UNITED STATES PATENT AND TRADEMARK OFFICE

APPLICATION NO.	FILING DATE	FIRST NAMED INVENTOR	ATTORNEY DOCKET NO.	CONFIRMATION NO.
10/665,527	09/22/2003	Eung-Su Kim	0630-1847P	5920
2292	7590	03/01/2005	EXAMINER	
BIRCH STEWART KOLASCH & BIRCH PO BOX 747 FALLS CHURCH, VA 22040-0747			VAN, QUANG T	
			ART UNIT	PAPER NUMBER
			3742

Office Action Summary	Application No.	Applicant(s)	
	10/665,527	KIM ET AL.	
	Examiner	Art Unit	
	Quang T Van	3742

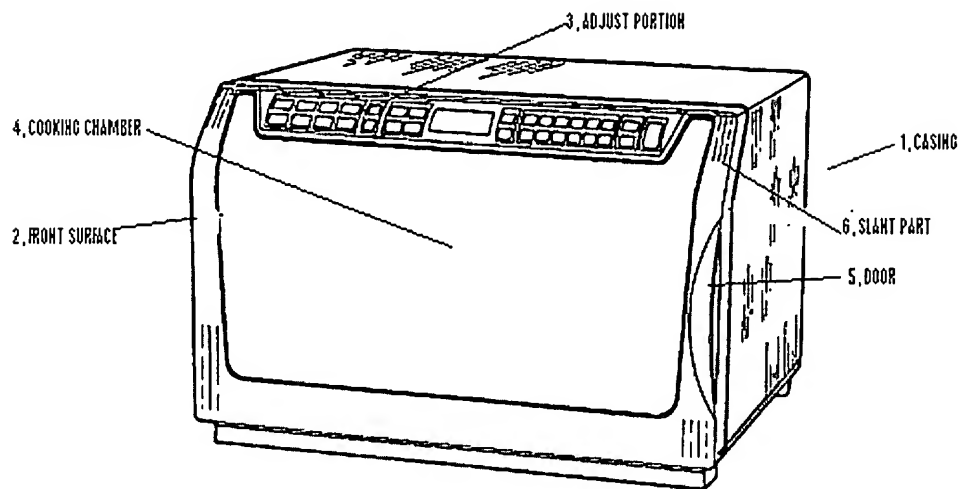
3. Claims 1-2 and 6 are rejected under 35 U.S.C. 102(e) as being anticipated by Choi (US D463200). Choi discloses, figure below, a microwave oven comprising a casing (1) which forms an appearance and has a front surface (2) backwardly slanted and an adjusting portion (3) formed at the slanted part (6); a cooking chamber (4) formed inside the casing (1) for cooking food; and a door (5) retractably combined at a side of the casing to rotate about a substantially vertical axis formed by the side of the casing and slanted correspondingly the casing (1) in order to opening and close the front surface of the cooking chamber (4).

FIG.1

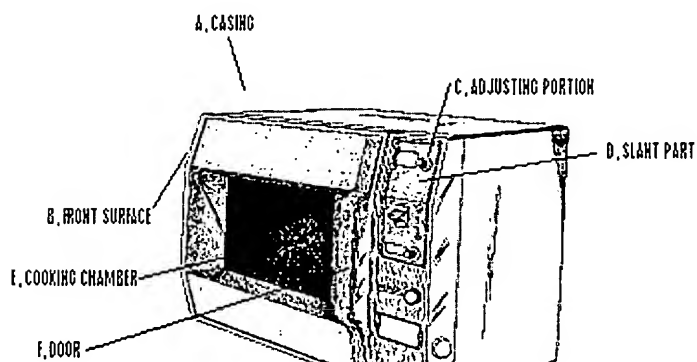
4. Claim 1 is rejected under 35 U.S.C. 102(b) as being anticipated by Pitstick et al. (US D242,421). Pitstick discloses, figure below, a microwave oven comprising a casing (A) which forms an appearance and has a front surface (B) backwardly slanted and an adjusting portion (C) formed at the slanted part (D); a cooking chamber (E) formed inside the casing (A) for cooking food; and a door (F) retractably combined at a side of the casing to rotate about a substantially vertical axis formed by the side of the casing and slanted correspondingly the casing (A) in order to opening and close the front surface of the cooking chamber (E).
